Product / Process Change Notification (PCN)

PCN #: PCN_IndSL2_20230907

Affected Series: WE-SL2; P/N 744XXX(S)

744226S

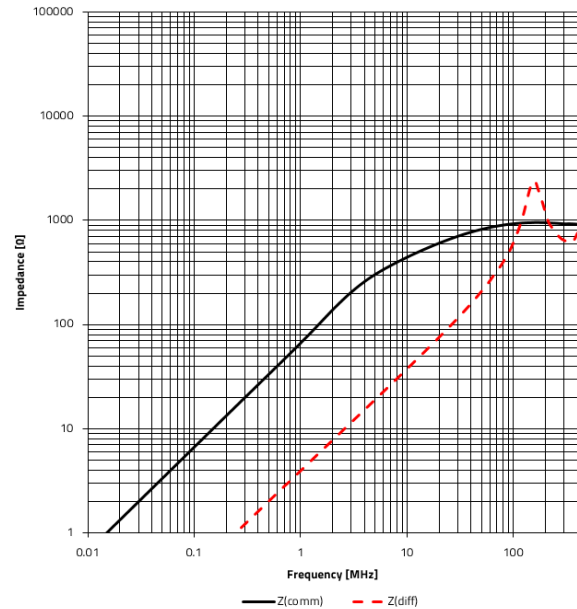
<u>Before change</u>	<i>Two core suppliers.</i>
<u>After change</u>	<i>One core supplier terminated and two additional suppliers will be added for a total of three.</i>
